**RE: Applications PR-2023-008710 & SI-2025-00082
U-Haul Site Plan
8200 Jefferson St NE, Albuquerque, NM**

Thank you for your time reviewing the U-Haul Site Plan application for the proposed development at 8200 Jefferson St NE. We received your comments dated February 11, 2025 and have addressed your comments. Below we have copied all your review comments and then provided written responses explain how each item was addressed.

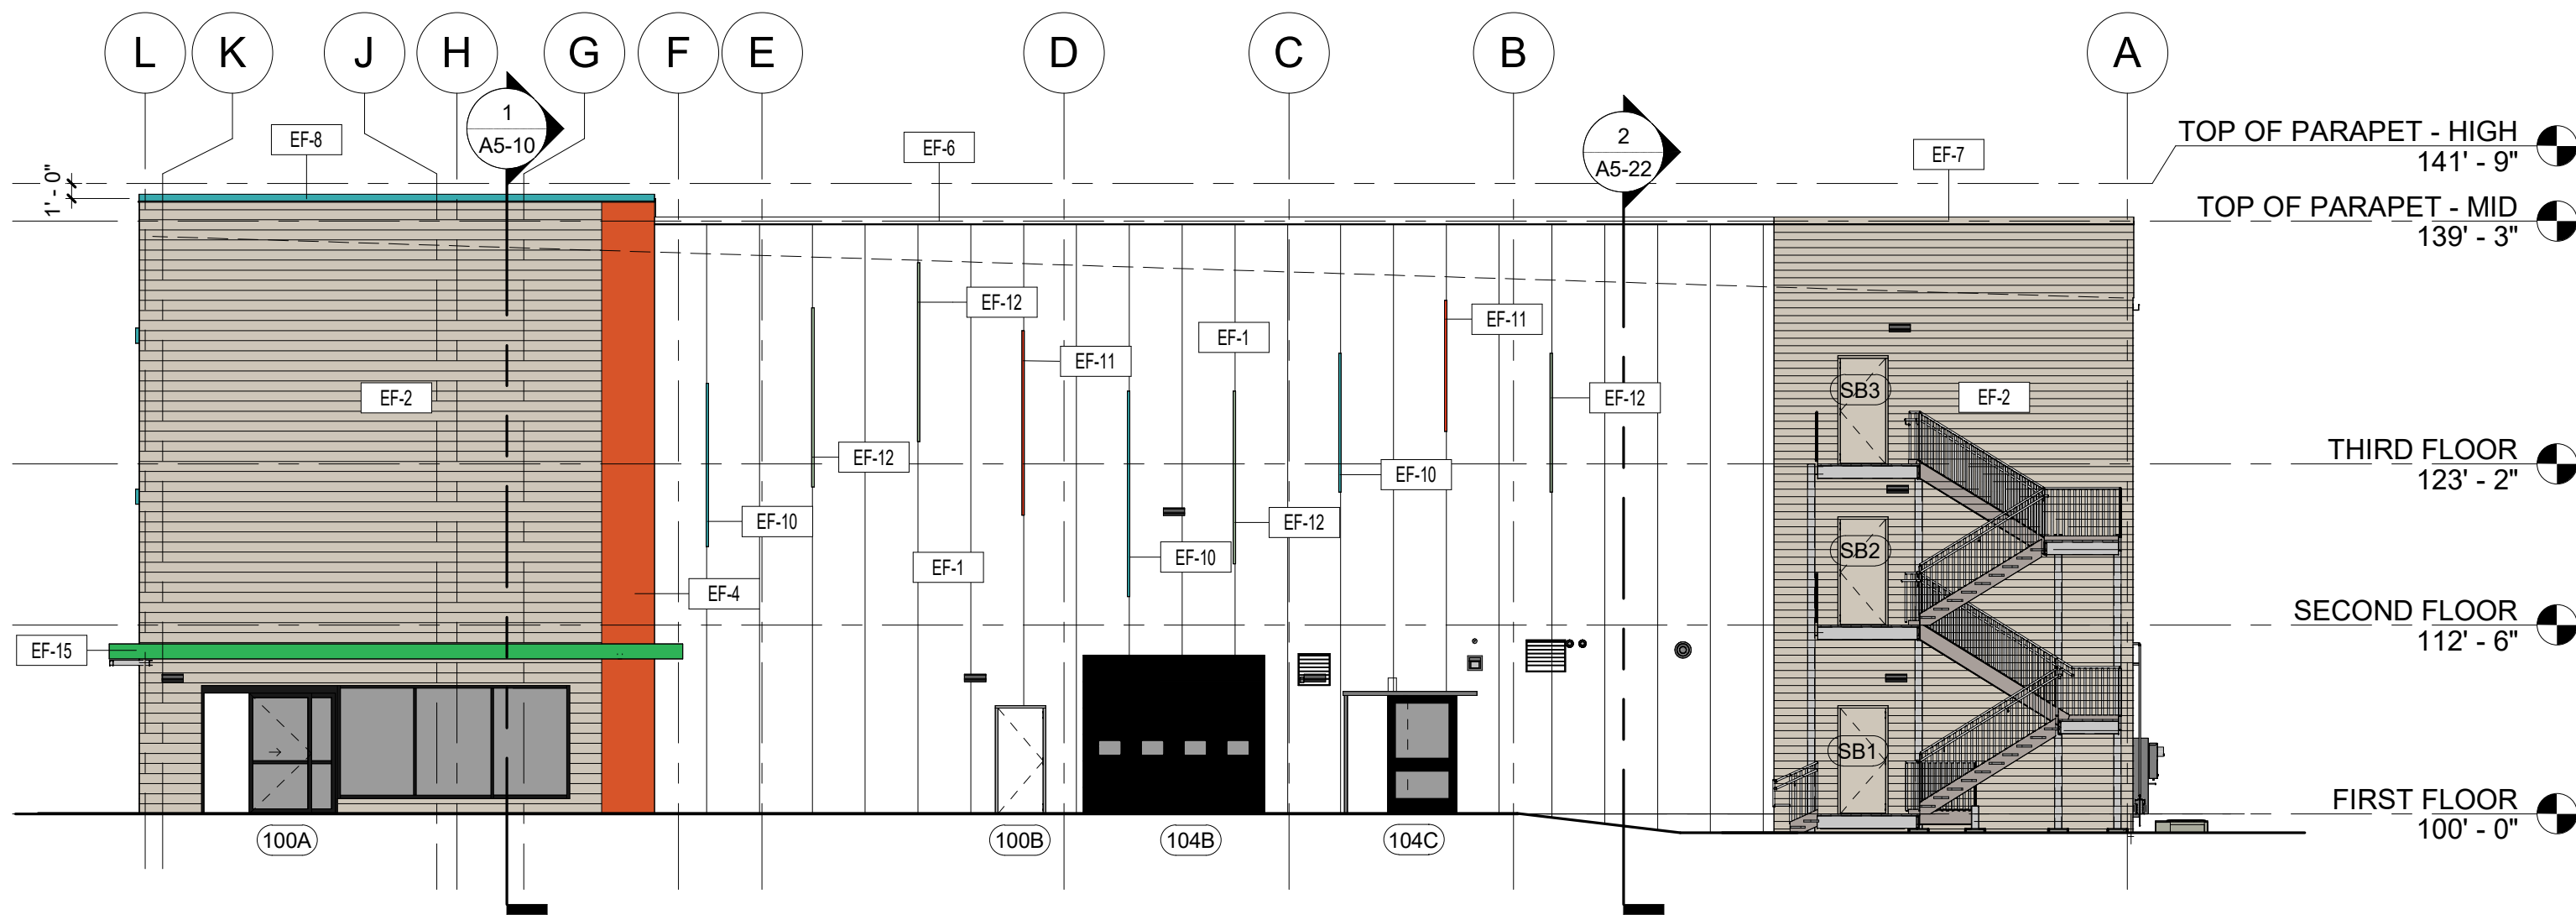
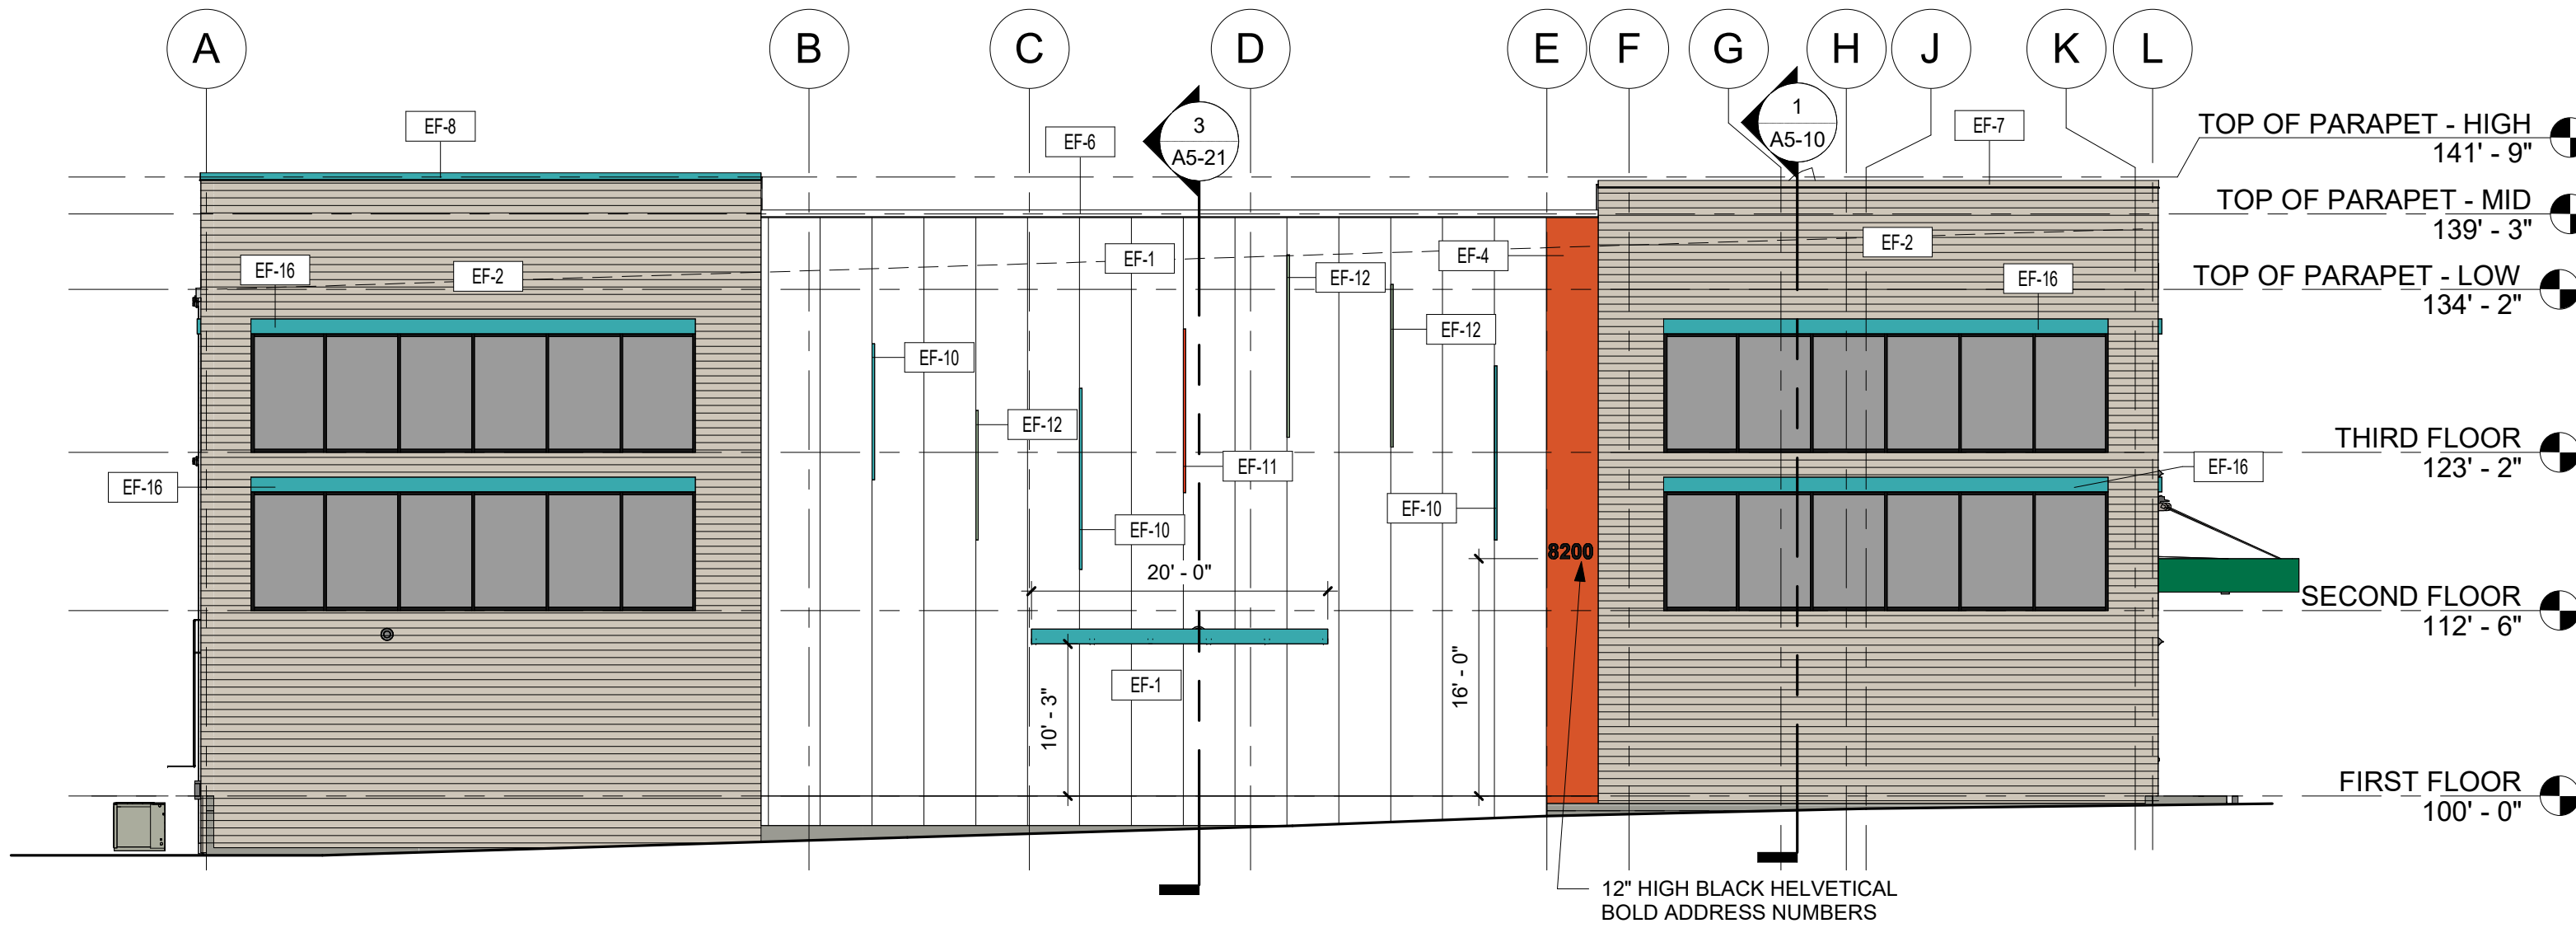
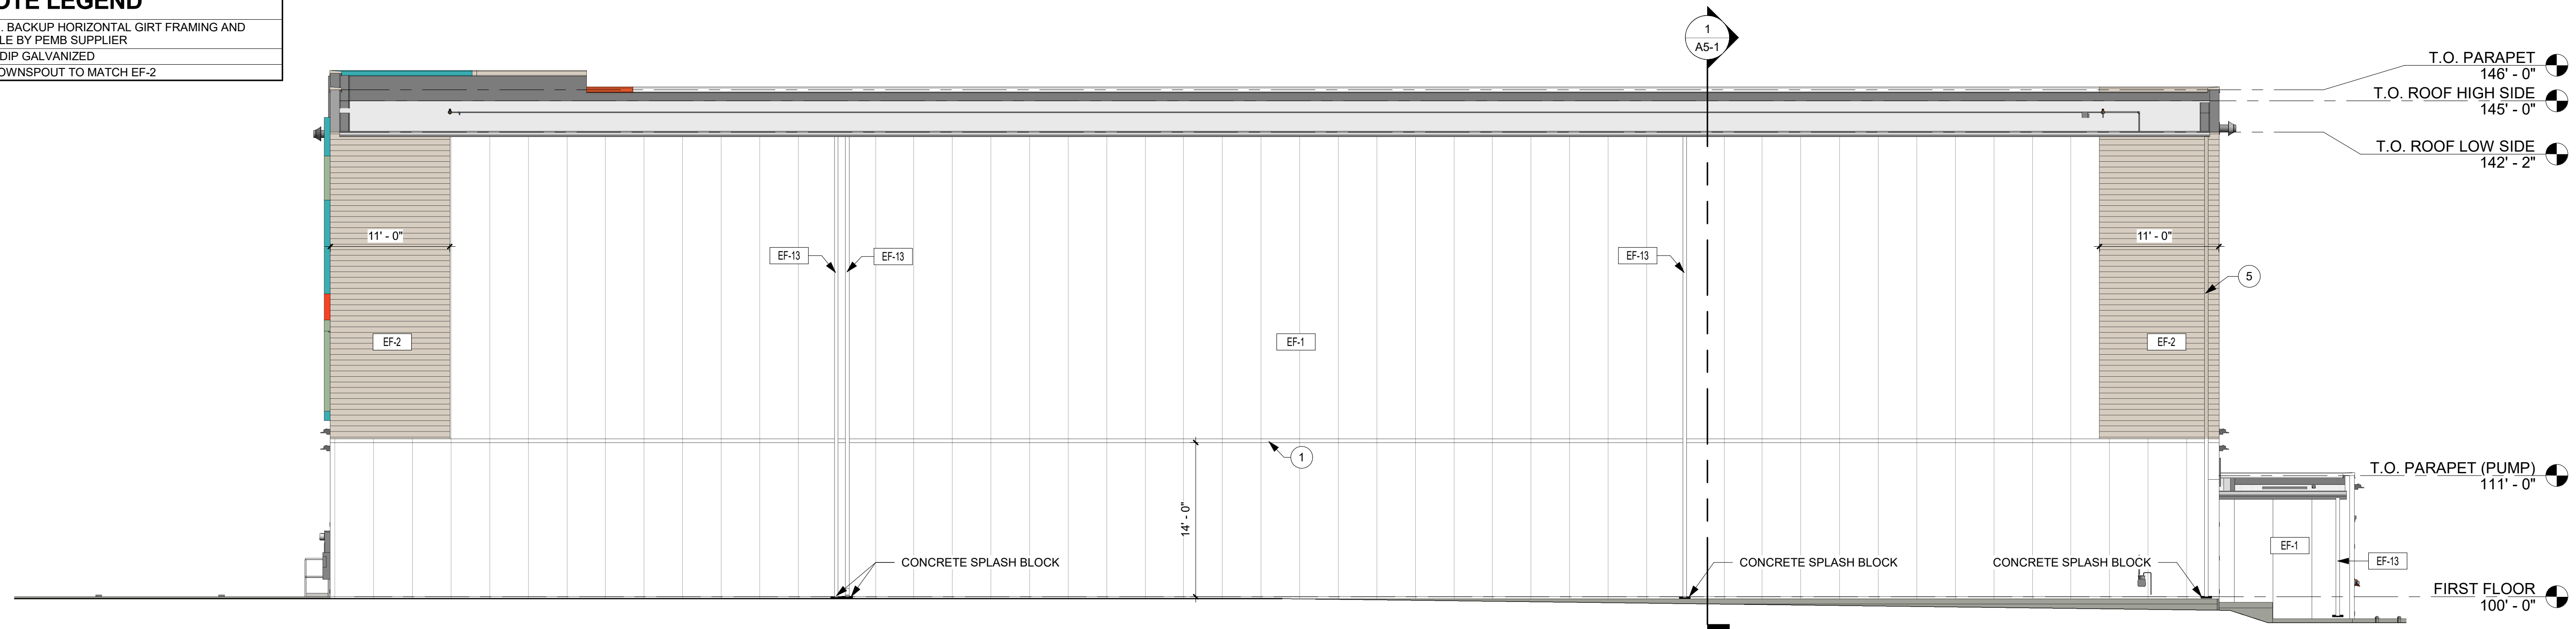
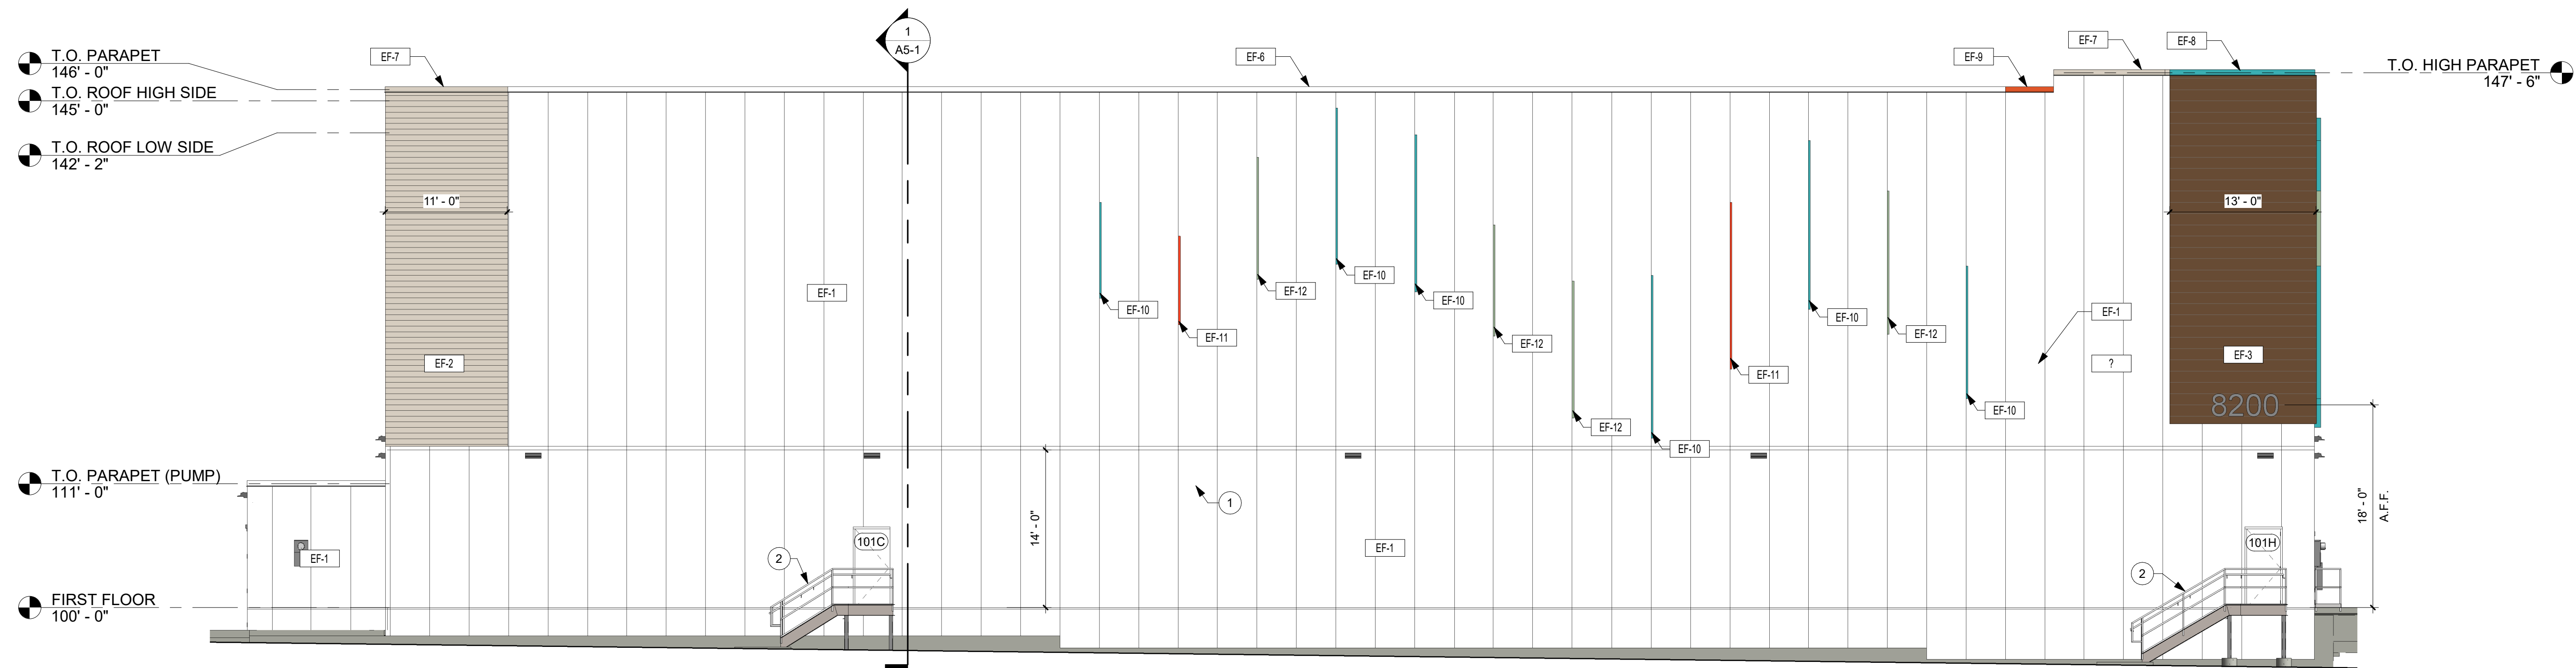
11. Elevation pages need to include details on how the project will be meeting the specific requirements listed in the memo above. Provide additional elevation detail to demonstrate and explain compliance with all the criteria in IDO section 5-11. Include height dimensions.

*This should include areas such as windows, doors, changes in façade. This can be addressed by adding detail to the elevation sheet or within a comment response.

Restrict continuous indoor light visible from the building windows from dusk to dawn. Motion sensor lights are a successful alternative because the lights turn on only when someone is in the building. Do not light up brightly colored faux doors in windows, or other trademark related signs/symbols which would effectively function as unauthorized 'signage' for the development. Please note color of faux doors on site plan; the current color appears dark and is acceptable.

"Rolled doors visible in any faux windows must match the color of the building façade, and will not highly visible when lit."

ISG Response: This has been updated.
